TAB Punch List - CFA 02665

Prepared by Will T

May 22, 2025

#62 [UNIT 503] [NEW] Trane equipment missing FAT field kits.

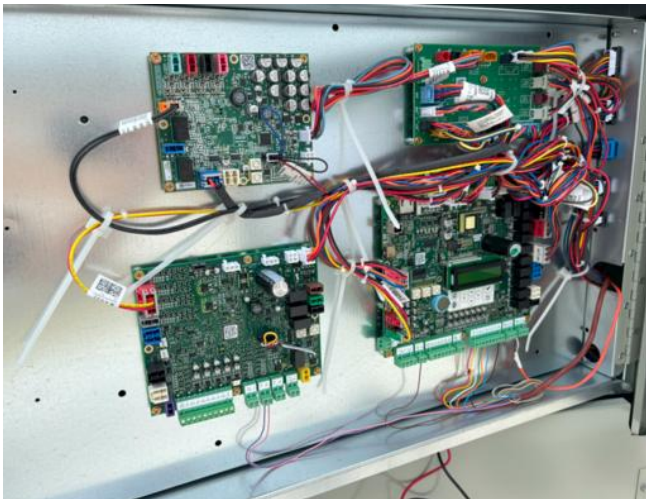
Trane equipment does not have additional manufacturer supplied, field installed relays, delay timer, or discharge temperature controller with FAT scheduled in design.

#61 [UNIT 999] [NEW] - AC-1 sensors

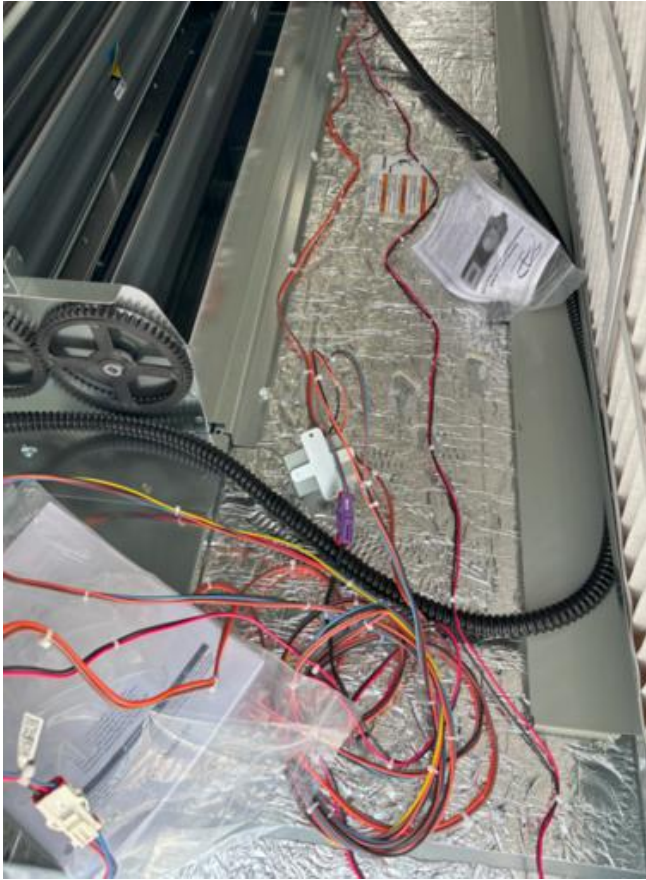
AC-1 sensor installation not complete. Mechanical contractor aware and is seeking Trane's advice on where they should be installed.

#55 [UNIT 999] [NEW] - Trane Symbio settings

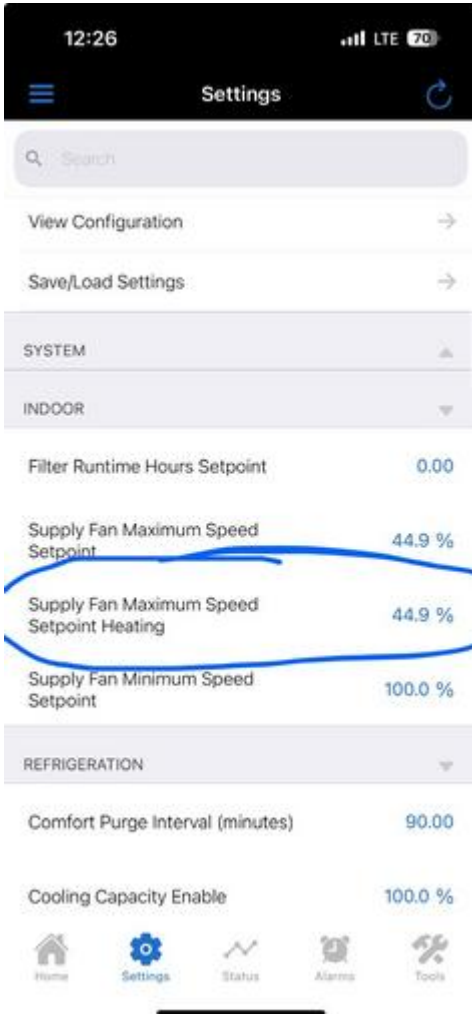
Some Trane units are showing a heat CFM on the Symbio app. This is not typical for Chick-fil-A RTU's. Ensure that the units are configured properly.

#48 [CNTL 999] [NEW] - Trane control wiring

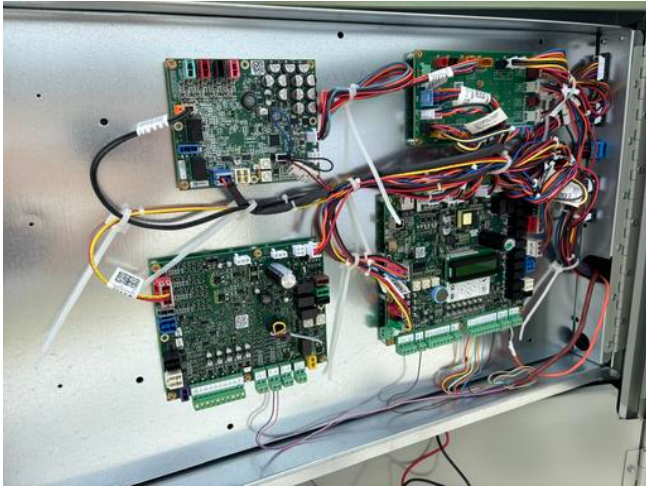
Wiring from Suncoast panel to Trane unit needs to be reviewed. The wires are currently run from P/P1 to terminal J8 but based on previous experience these need to be run to J20 for proper economizer operation. Currently AC's 1 and 4 economizers do not close during unoccupied mode.

#37 [REFG 999] [NEW] - WIC/WIF Condensing unit locations

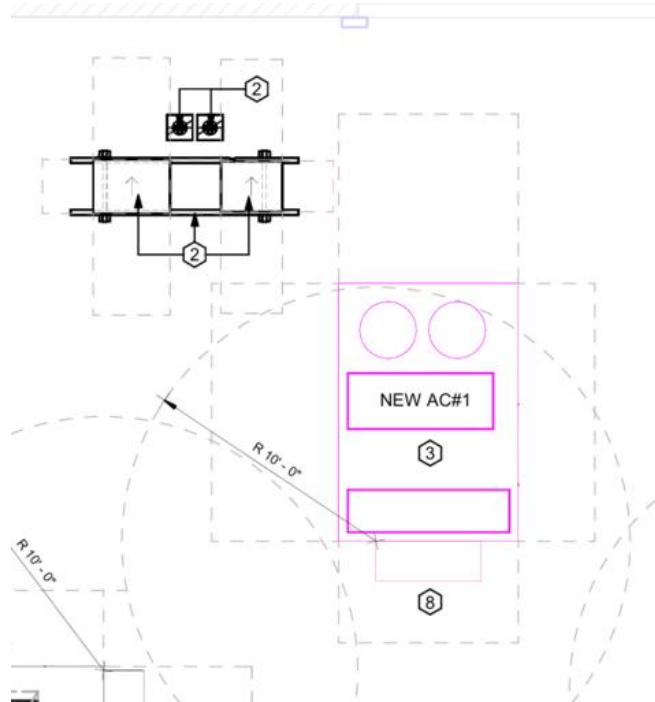
WIF/WIC condenser locations do not match the drawing

#27 [DUCT 499] [NEW] CRITICAL - Flex / HVAC ductwork insulation

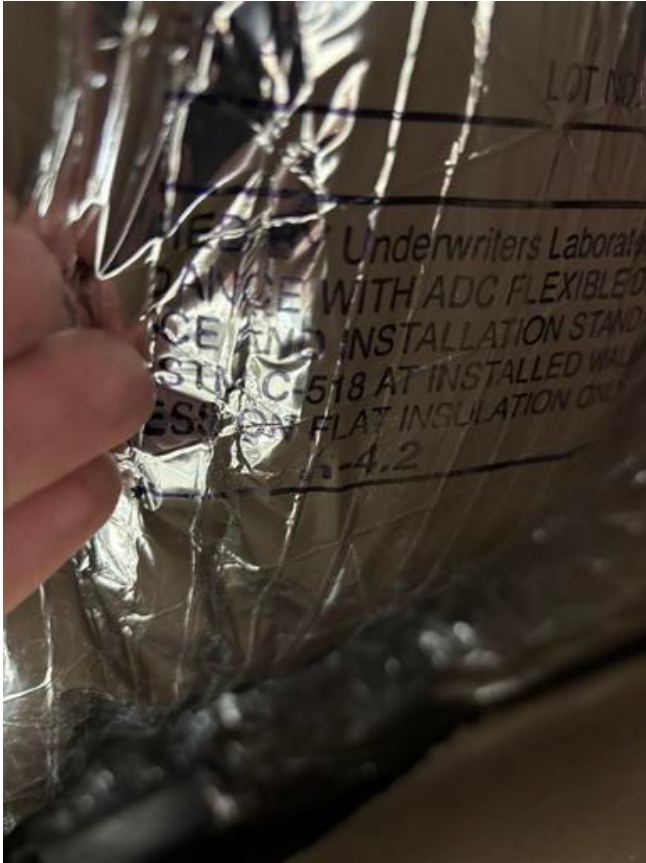
Flex ductwork is R-4.2 but the plans call for R-6. Unable to confirm the rating for the external insulation on the HVAC so the rating on this needs to be provided by the mechanical contractor.

#6 [UNIT 999] [NEW] (MISC) AC electrical lugs

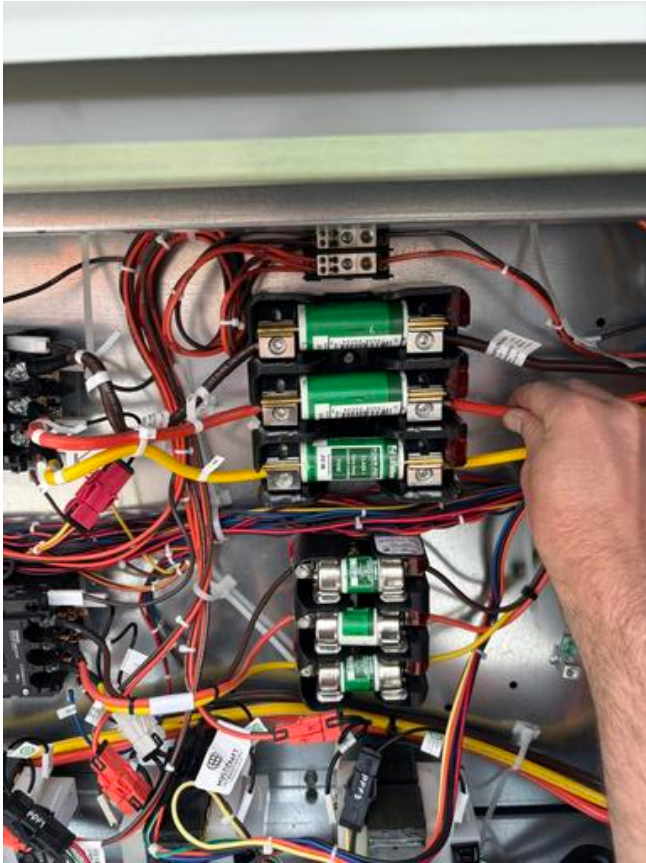
Electrical connection found loose from the factory on AC-1. Needs to be tightened
